Subject: Draft Environmental Assessment (DEA) for
Kalihi Valley Reconstructed Sewer,
TMK: 1-3-29, 1-3-33, 1-3-37 to 38, 1-4-01 to 06,
1-4-08 to 14, 1-4-17, 1-4-19 to 21, 1-4-23 to 25 Kalihi, Oahu

FINAL ENVIRONMENTAL ASSESSMENT

KALIHI VALLEY RECONSTRUCTED SEWER

FIGURE 2

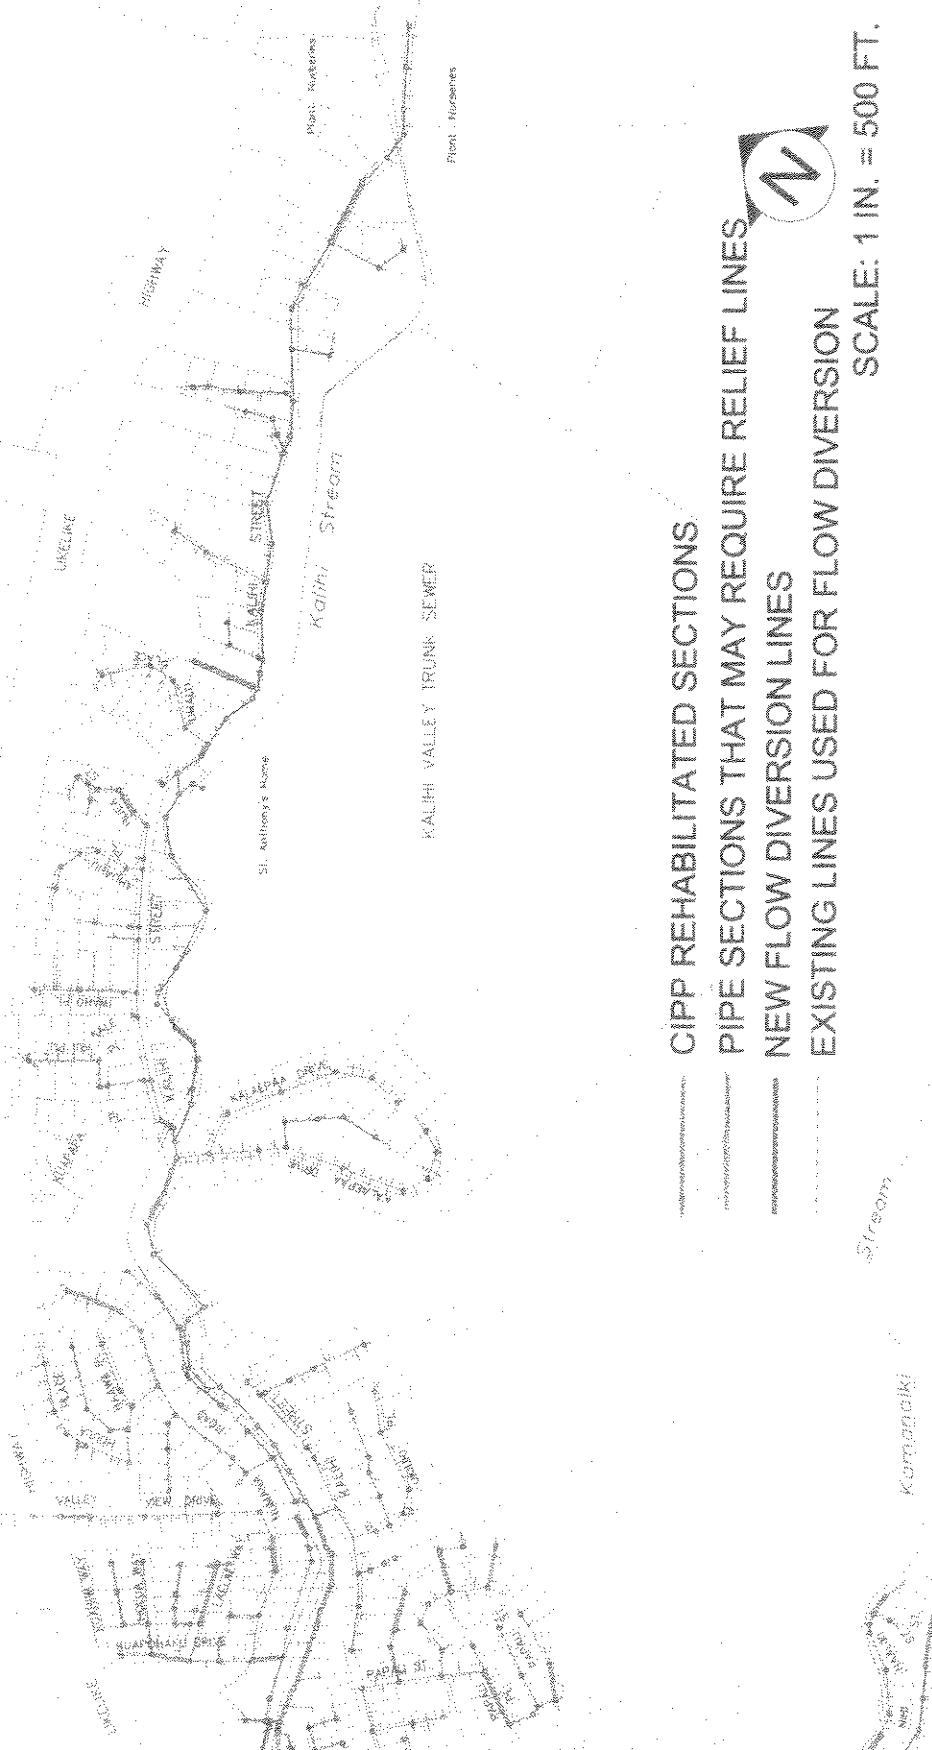
Kapalama Elementary is never identified in all the maps of the affected area. In the Figure 5 Zoning Map, the school's campus is left completely blank.

Figures 1, 2 and 5 were revised in the Final Environmental Assessment (FEA), to clearly indicate the locations of the three elementary schools that could be affected by the project (Kalihi, Kalihi Uka and Kapalama). Specific mention of these three schools will be included in paragraph V.D *Description of the Affected Environment under Land Use*. Although no sewer work is proposed immediately adjacent to Kapalama Elementary or the other two schools, traffic in the vicinity of the schools may be affected by construction operations. The Contractor shall coordinate with the principals of these three schools providing advance notification of possible utility disruptions, traffic detours that will affect emergency vehicle access and noise and odors impacts.

Figure 2 is a color coded map showing the locations of all proposed sewer improvement work, sewer line rehabilitation in red, sewer flow diversions in green and a sewer relief line in yellow.

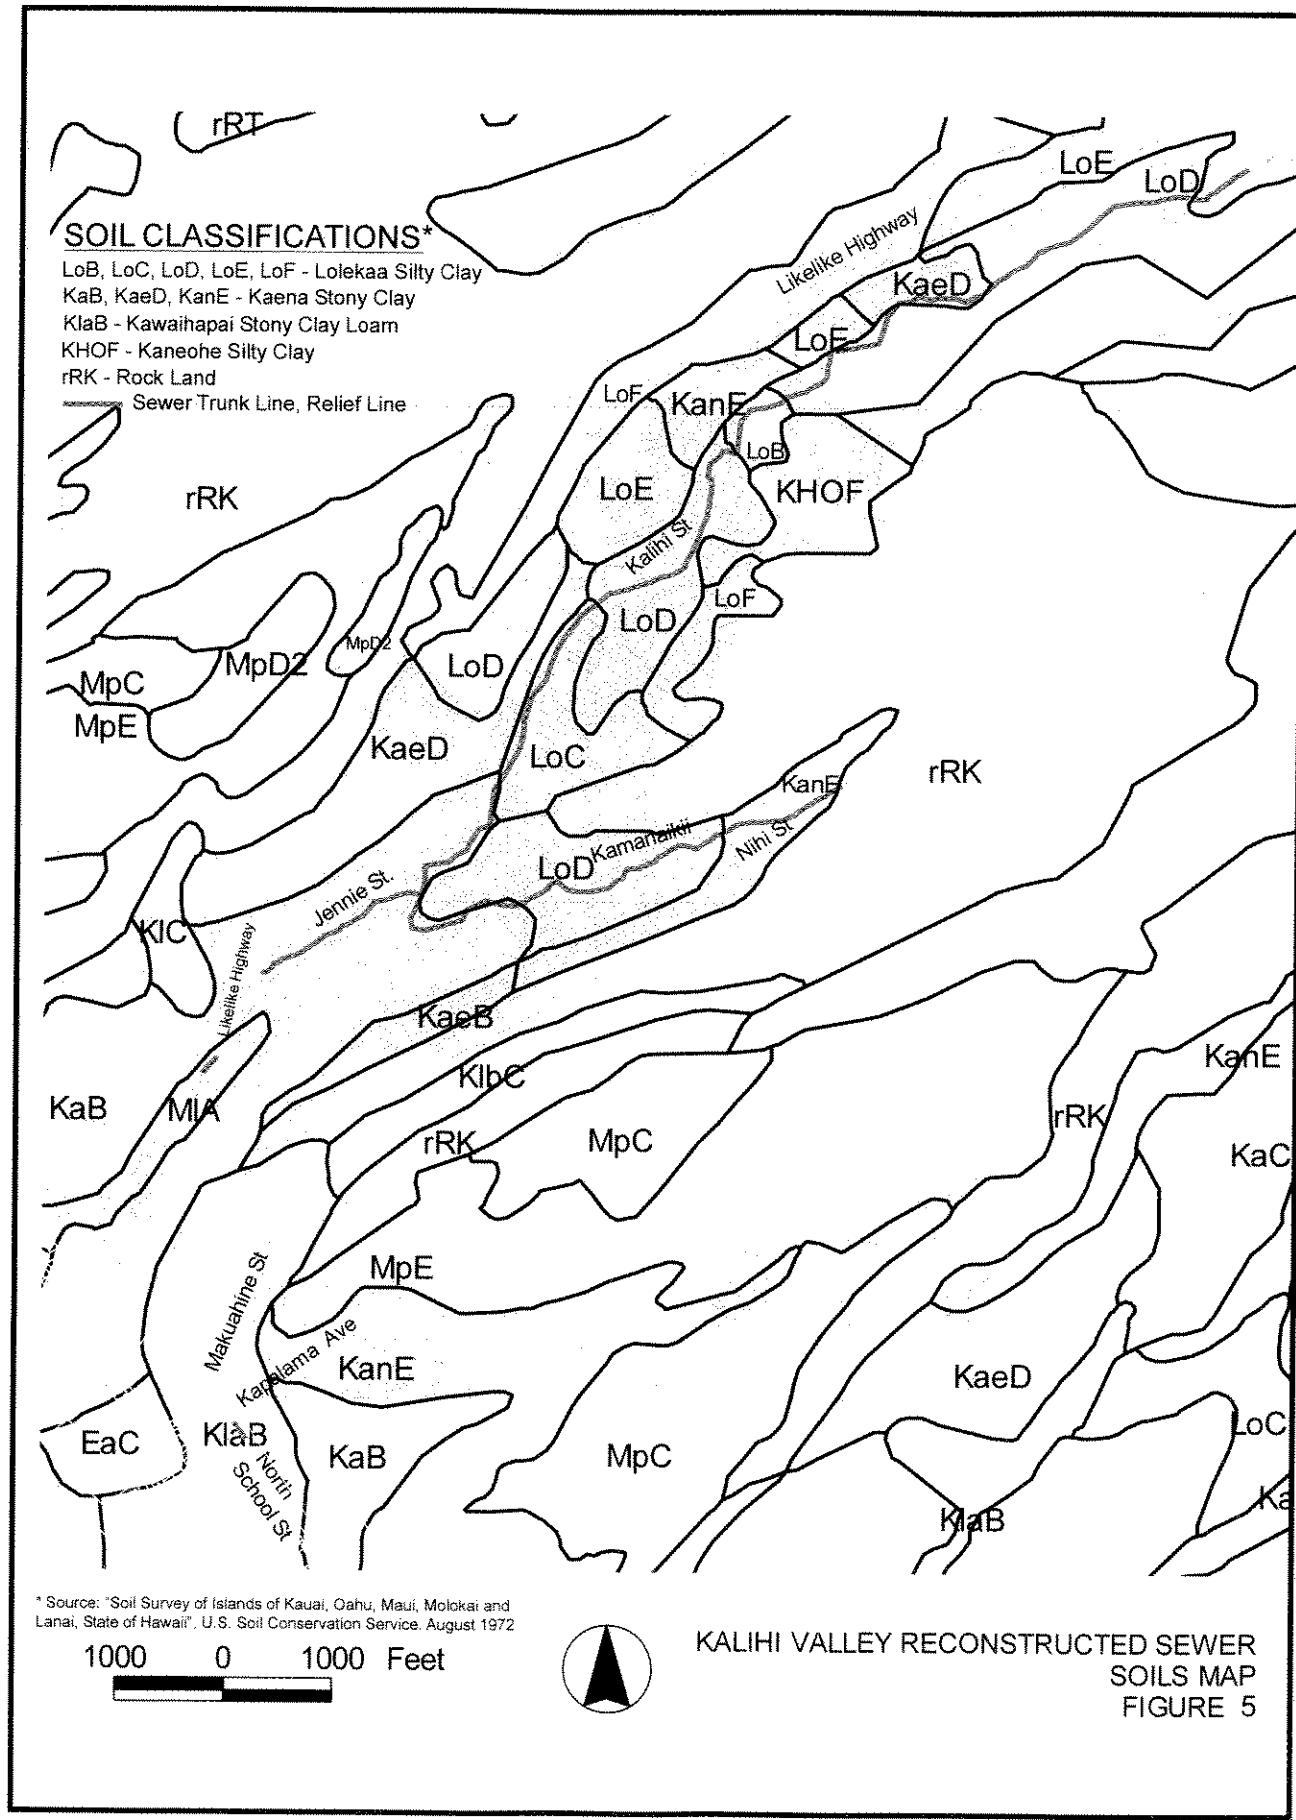
1. Section II, Summary Information – County zoning on page 3 and the two zoning maps (Figure 5): Add Medium Density Apartment zoning district after A-2.
2. Section III, Agencies, Organizations and Individuals Consulted on page 4: The Department of Business, Economic Development and Tourism should be listed under the State of Hawaii instead of the City and County of Honolulu (Note: the City has an Office of Economic Development).
3. Section V, Description of the Affected Environment – B, Geology/Soils on page 10: Add the source of the soil types listed, for example, the U.S. Department of Agriculture Soil Conservation Service Soil Survey.

1. Section II and Figure 5. The zoning designation for A-2 was revised to Medium Density Apartment.
2. Section III, The Department of Business, Economic Development and Tourism was moved under the list of State Agencies.
3. Section V and Figure 4. The United States Department of Agriculture Soil Conservation Service was added as the source of the soil types listed. The types of soil was at the proposed site of the relief line on North School Street was also added to Section V and Figure 4.
